UNITED STATES PATENT AND TRADEMARK OFFICE

10/563,172

Office Action Summary	Application No. 10/563,172	Applicant(s) JUSKEY ET AL.	
	Examiner Jasmine J. Clark	Art Unit 2815

Claims 1-5, and 11 are rejected under 35 U.S.C. 102(e) as being anticipated by Sakamoto et al. (US 2005/0056916 A1).

FIG.8

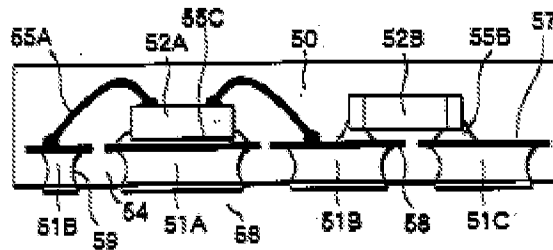
Sakamoto '916 discloses relating to a semiconductor package, comprising: a package body (50); a semiconductor device (52A) disposed within the package body (50); at least one passive component (52B) disposed within the package body (50); and a lead frame (51A-51C) formed from electrically material, the lead frame including a plurality of leads electrically connected to I/O pads on the semiconductor device (52A), and wherein the I/O pads of the semiconductor device (52A) are wire bonded (for claim 11), each of the leads including a first surface exposed from the package body for electrical connection to the external circuit, and a plurality of first interposers (57, i.e.,) electrically connected to the at least one passive device (52B), at least one interposer in the plurality of interposers being electrically connected to at least one lead in the plurality of leads for electrically connecting the at least one passive device (52B) with the external circuit; and wherein the package body is formed by a molding compound encapsulating at least a portion of the semiconductor device (52A), at least a portion of the at least one passive component, and at least a portion of the lead frame (claim 2).

To further clarify that the package body is a sealing resin and it is part of the molding compound.

Concerning claim 3, wherein the first surface of the leads are exposed substantially coplanar with a surface of the package body (50) (see Fig. 8 above).

Concerning claims 4 and 5, wherein the at least one passive device (52B) is selected from the group consisting of, for example capacitor, please see para [0165].
